1 Q. Reference: Teshmont Report - Section 7 – Conclusion (pg 38):

Island Interconnected System Supply Issues and Power Outages

Figure 1
 Breakdown of Average FEU By
 Equipment Category of All Reporting Thyristor
 HVDC Systems (2009-2010)

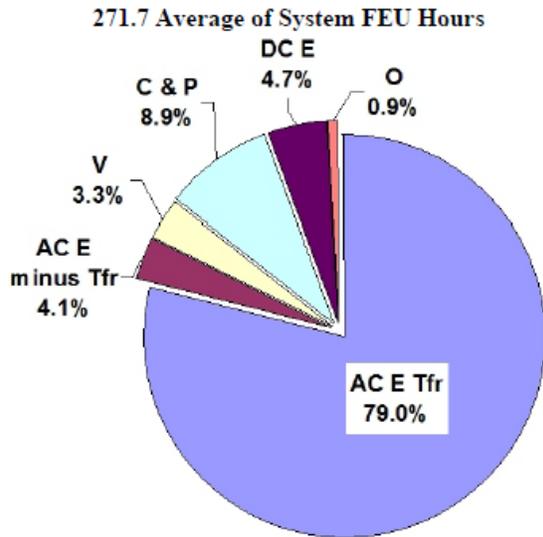
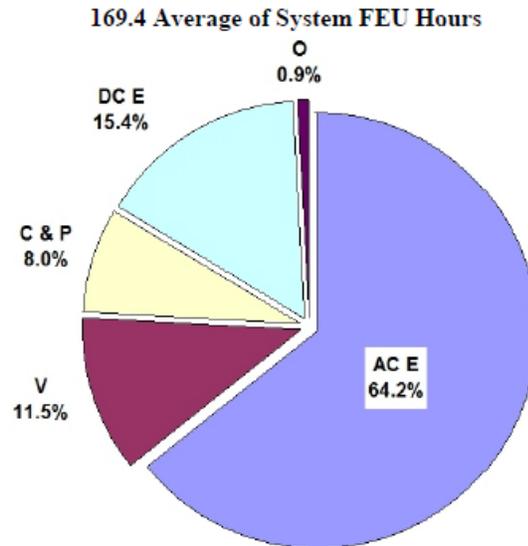
3 **With reference to CA/SBA IR-194 and Appendix 3.01, page 76, please provide any reports,**
4 **studies, reviews, or other materials with the analyses of the industry statistics related to the**
5 **based on VSC technology HVDC converter valve groups and their cooling systems,**
6 **including aging evaluation, forced outage rates, reliability in service, failure modes, etc. To**
7 **the extent a report is subject to the strict copyright laws (e.g., a CIGRE report) please**
8 **provide a summary of the report observations and conclusions.**

12 As indicated in the response to CA/SBA IR-194, protocols have been developed for data
13 collection on VSC installations, but the industry has not yet started compiling the statistics. The
14 following is summary data from CIGRE for LCC installations for the operating period
15 2009-2010, showing the relative contributions of various components in an HVdc system to the
16 overall Forced Energy Unavailability of the system. The components referenced in the figure
17 are:

4
 5 These statistics demonstrate that in both periods (1983-2008 and 2009-2010); AC Equipment and
 6 Auxiliaries (AC-E) are the dominant contributors to Forced Energy Unavailability. Within the
 7 category of AC Equipment and Auxiliaries, transformers have been a significant contributor. The
 8 contributions for Valves (V) cannot be validated for VSC installations, but a significant
 9 reduction of FEU contributions from LCC thyristor valves has been observed in recent years.
